Re: Initial Submission Review – Enclave at Saddle Rock – Site Plan
Application Number: **DA-1074-15**
Case Number: **2019-4016-00; 2019-3048-00**

Please find included comment responses from the 2nd review comments dated August 31, 2021. Our comment responses are included in *red italics*.

THE ENCLAVE AT SADDLE ROCK GOLF CLUB NORTH SITE PLAN

DRAWING: LANDSCAPE SCHEDULE AND DETAILS

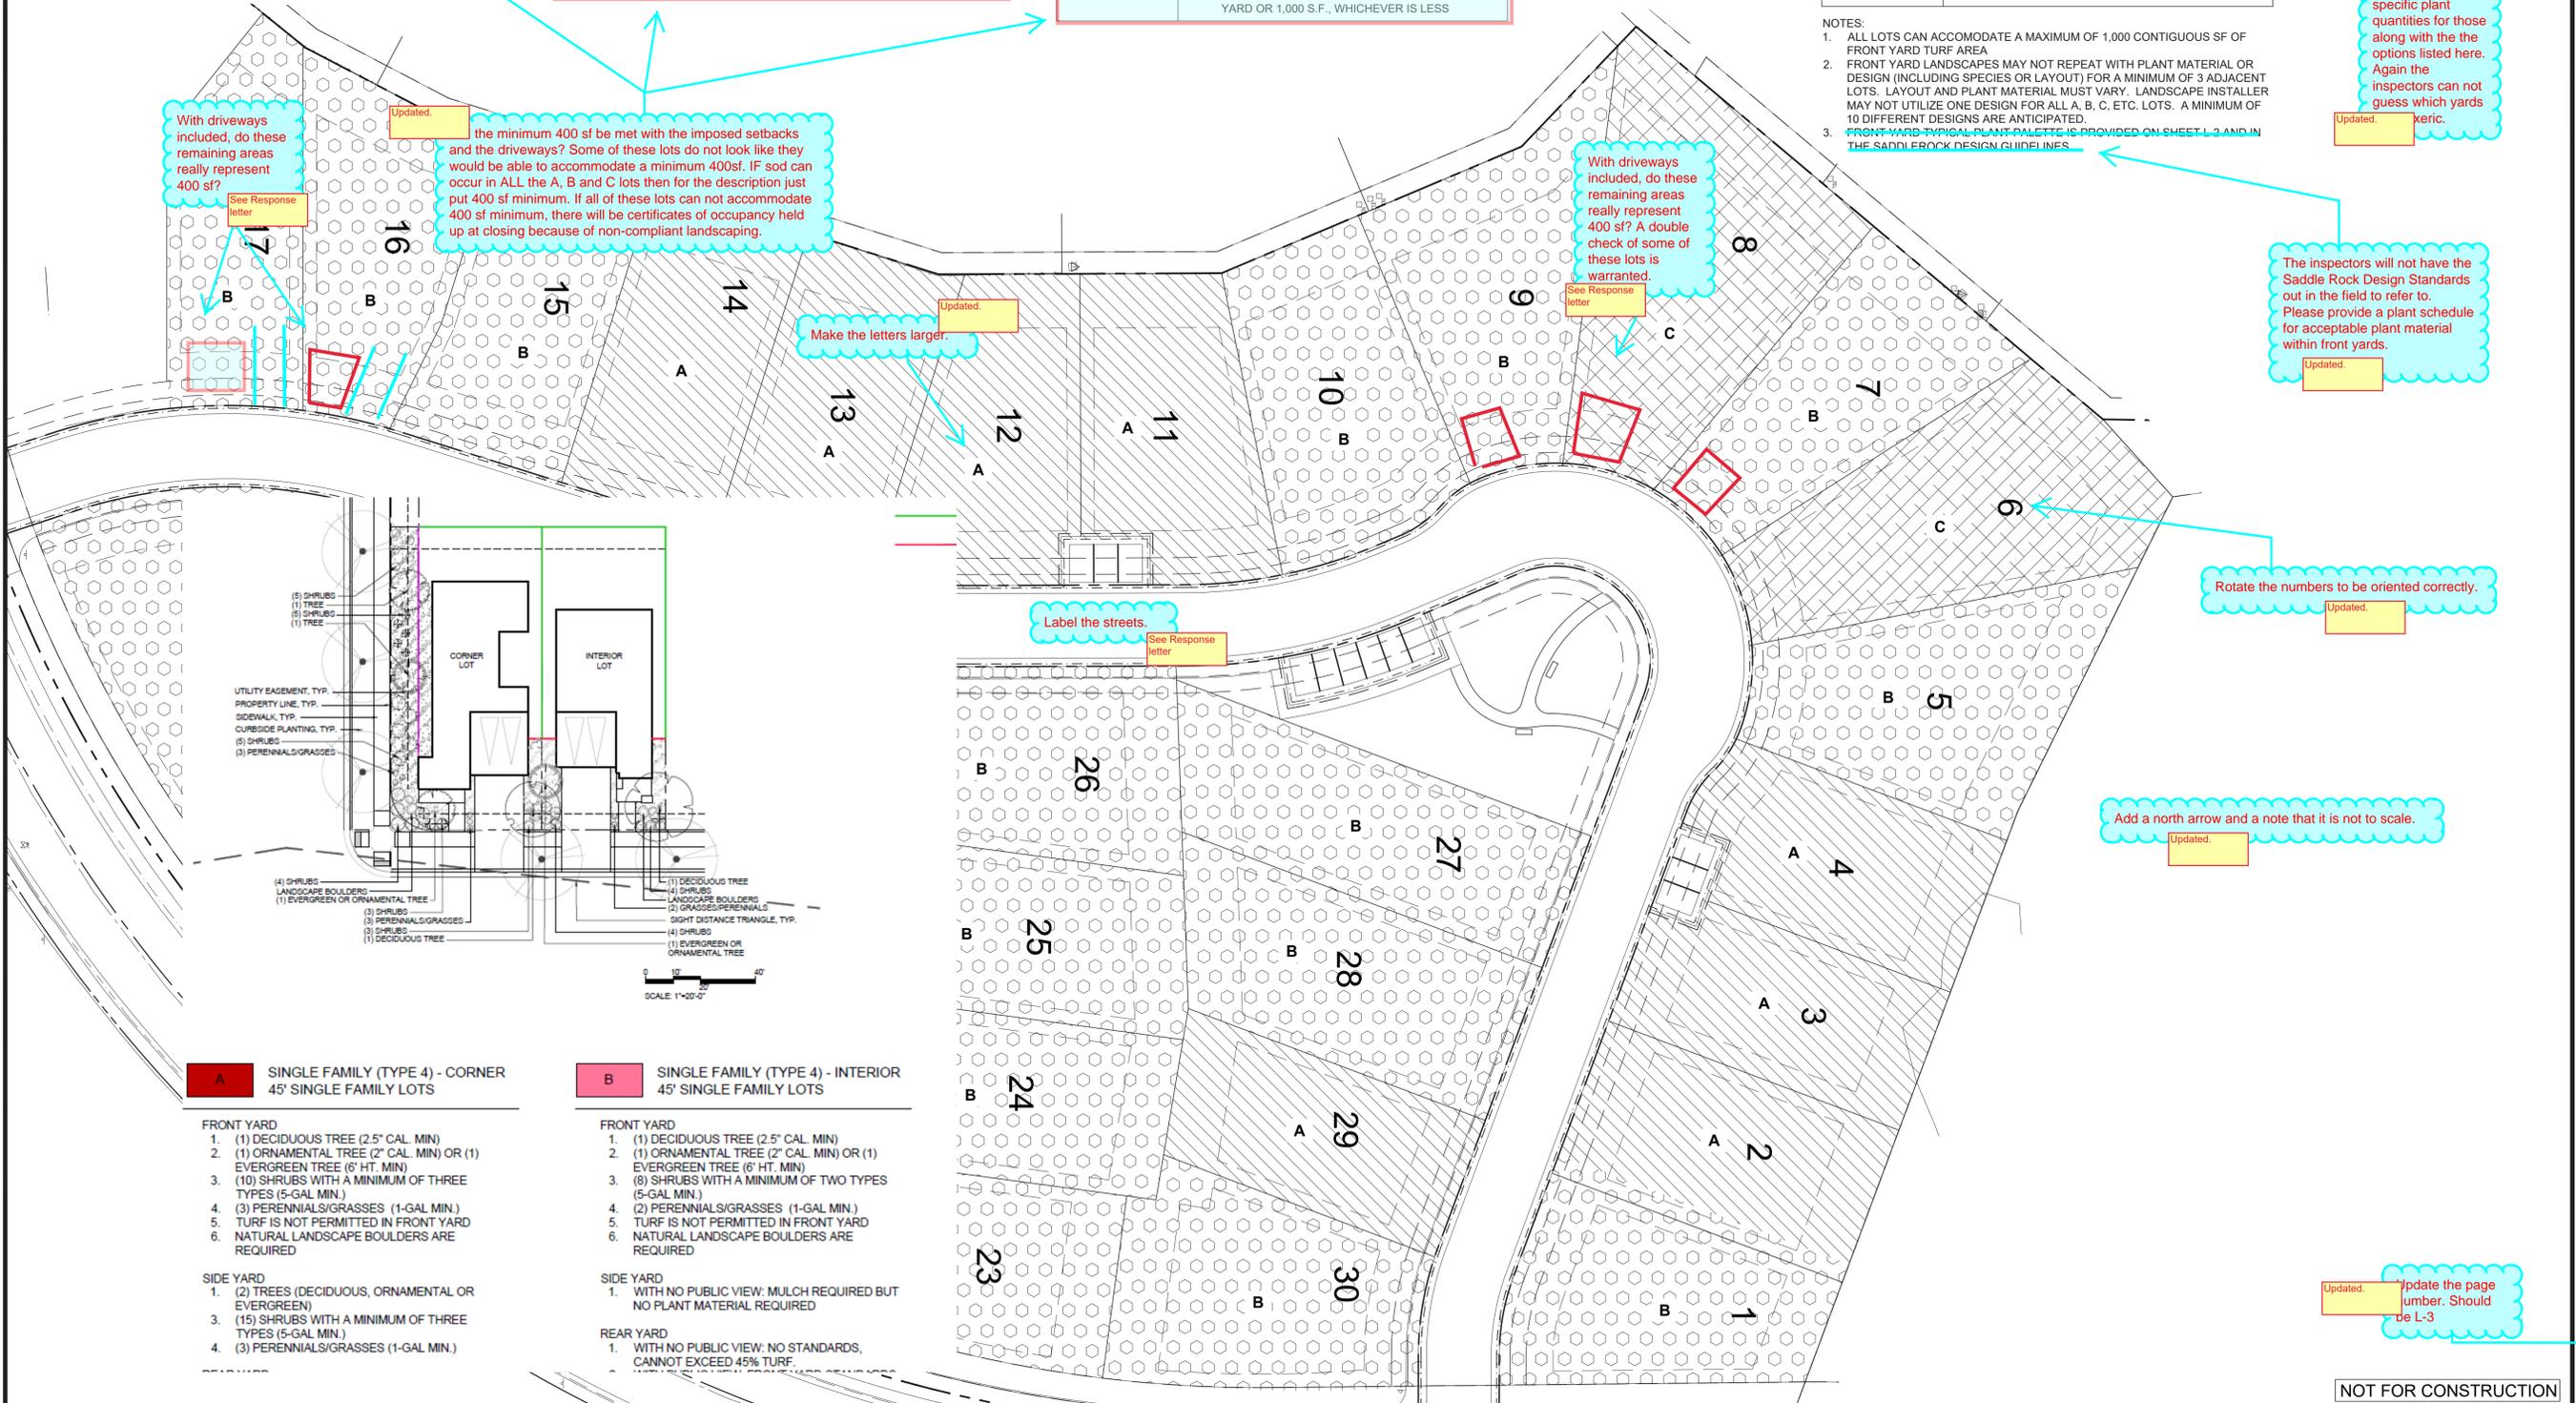
Updated.
You need to identify which lots these are and figure how many plants will need to be provided in the side yards. See example this sheet.

Updated.
You need to determine if there will be any xeric yards and note which ones they are and specify specific plant quantities for those along with the the options listed here. Again the inspectors can not guess which yards xeric.

Updated.
The inspectors will not have the Saddle Rock Design Standards out in the field to refer to. Please provide a plant schedule for acceptable plant material within front yards.

Updated.
Add a north arrow and a note that it is not to scale.

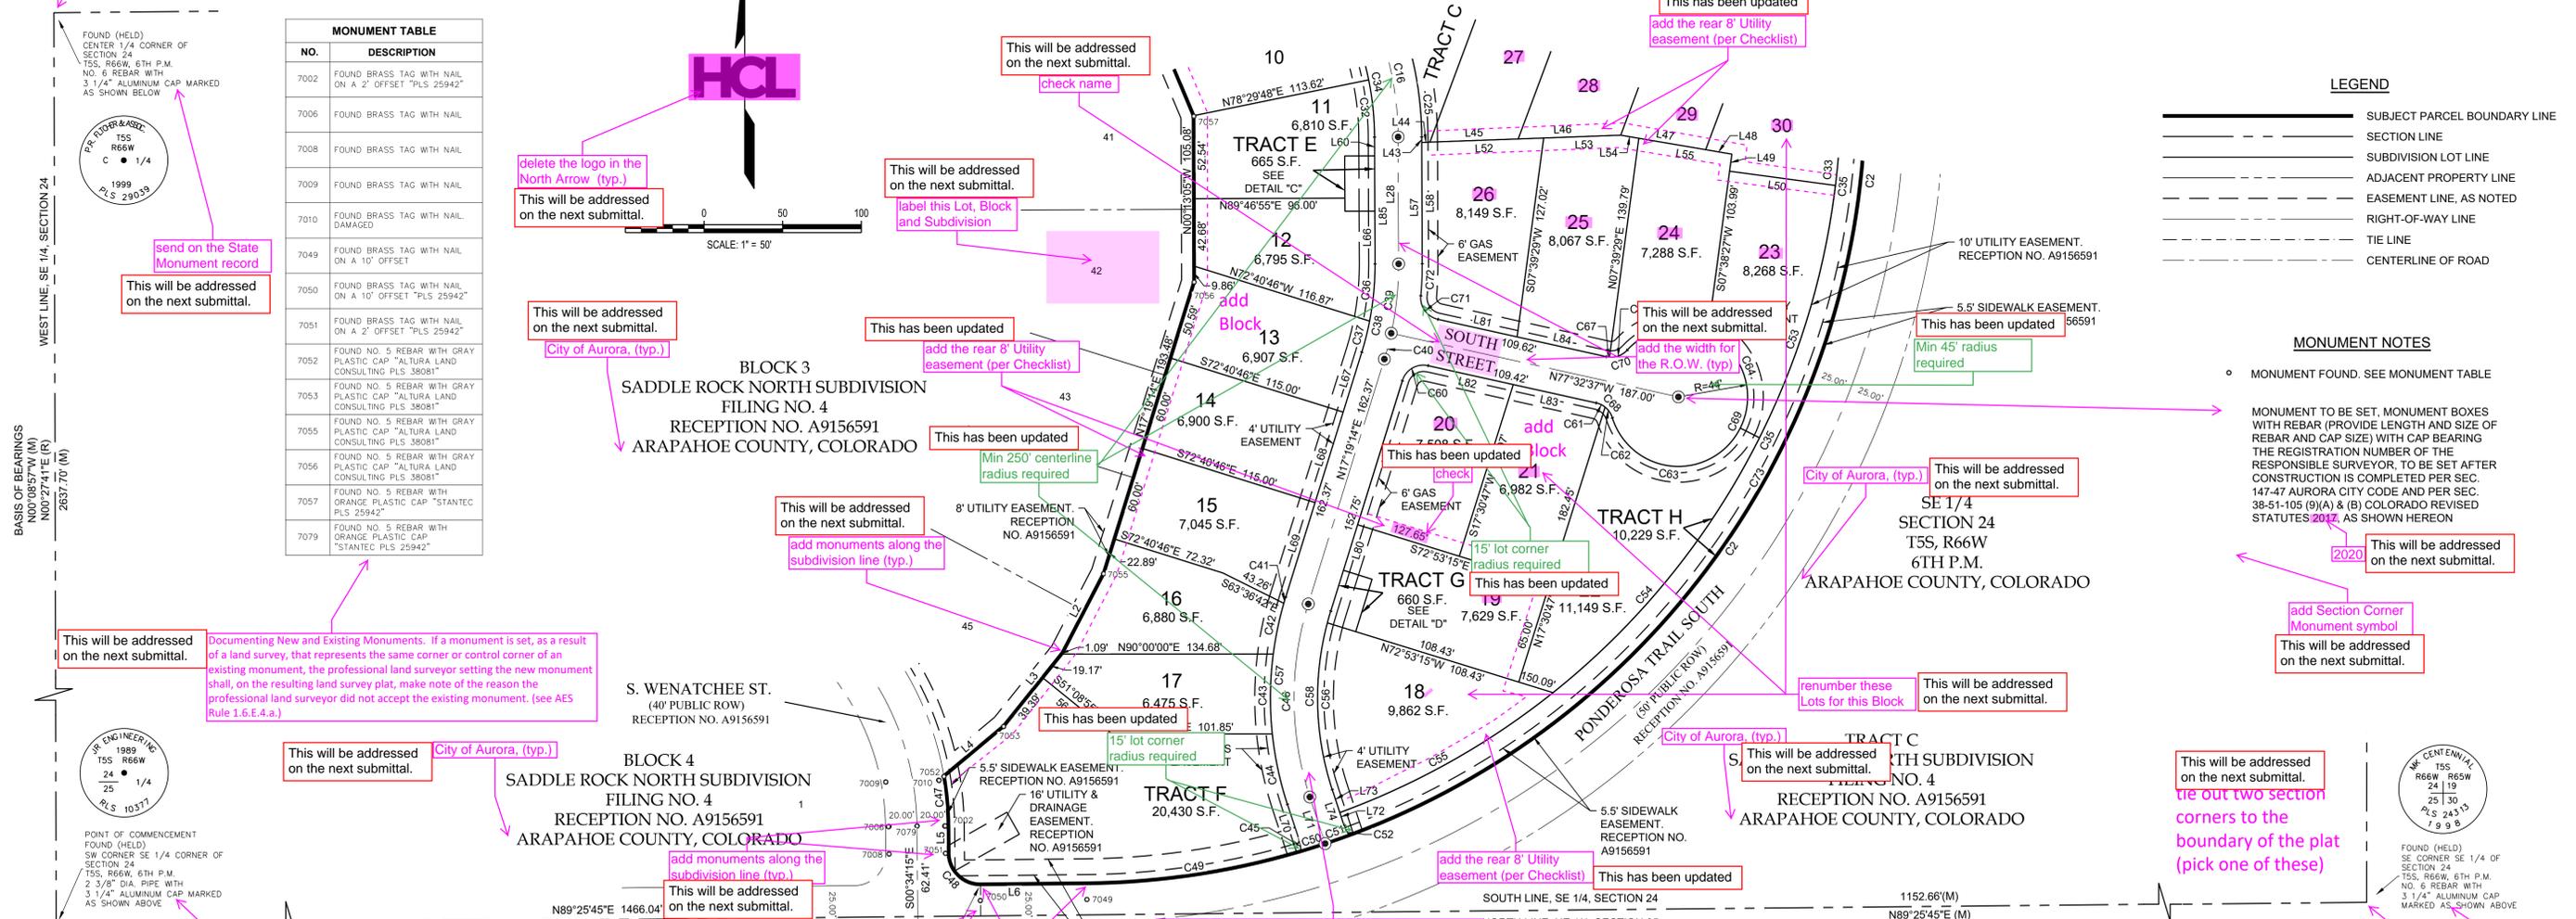
This will be addressed on the next submittal.
add the monument symbol (typ.)
tie out two section corners to the boundary of the plat (pick one of these)

This will be addressed on the next submittal.
Documenting New and Existing Monuments. If a monument is set, as a result of a land survey, that represents the same corner or control corner of an existing monument, the professional land surveyor setting the new monument shall, on the resulting land survey plat, make note of the reason the professional land surveyor did not accept the existing monument. (see AES Rule 1.6.E.4.a.)
